**Re: Request for Permit Modification to Change Approved C-147 ASTs to Earthen Containments at Select Earthstone Facility (1RF-505)**

**Re:    *Response to V. Venegas Email Received 9/21/2023 Regarding Permit Modification Request for Select Energy Earthstone Recycle Facility (1RF-505)***

# EARTHSTONE RECYCLE SELECT ENERGY

**1RF-505 - EARTHSTONE RECYCLE FACILITY ID [fVV2317950307]**

ANCHOR TRENCH DETAIL  
NOT TO SCALE

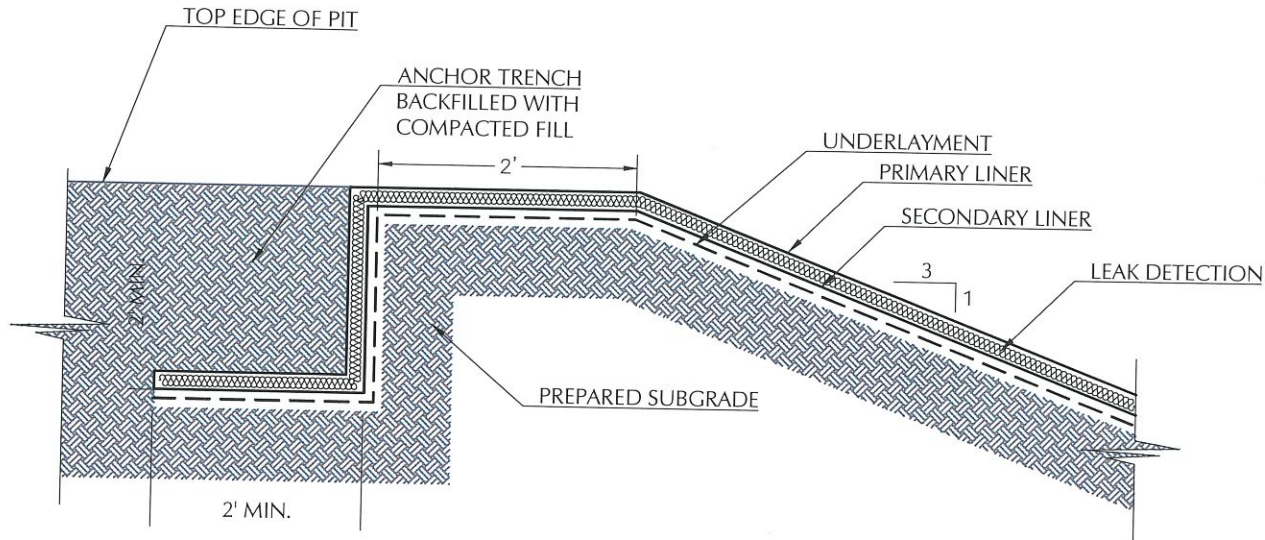
Select Energy is requesting a variance to Rule 34 Part 12(A)(4) requiring secondary liners to be 30-mil string reinforced LLDPE. Select is requesting approval to use 40-mil HDPE in place of the specified material in the proposed Recycle Containments. Based on our experience, we feel that the requested material will allow us to provide equal environmental protection in our impoundments.

The proposed liner system cross-section for the earthen containment is as follows: prepare subgrade, 10 oz. geotextile, 40-mil HDPE, 200-mil geonet, 60-mil HDPE. This will replace the cross-section required by the current rule. It should also be noted that this variance has been granted on past sites.

- The variance from 19.15.34.13.E NMAC for the installation of an audible "Bird-X Mega Blaster Pro" bird deterrence system is approved.
- The variance to 19.15.34.12.A.(4) NMAC for the installation on the AST containment of a 40-mil non-reinforced LLDPE secondary liner is approved. The proposed liner system cross-section for the earthen containment is as follows: prepare subgrade, 10 oz. geotextile, 40-mil HDPE secondary liner, 200-mil geonet, 60-mil HDPE primary liner.
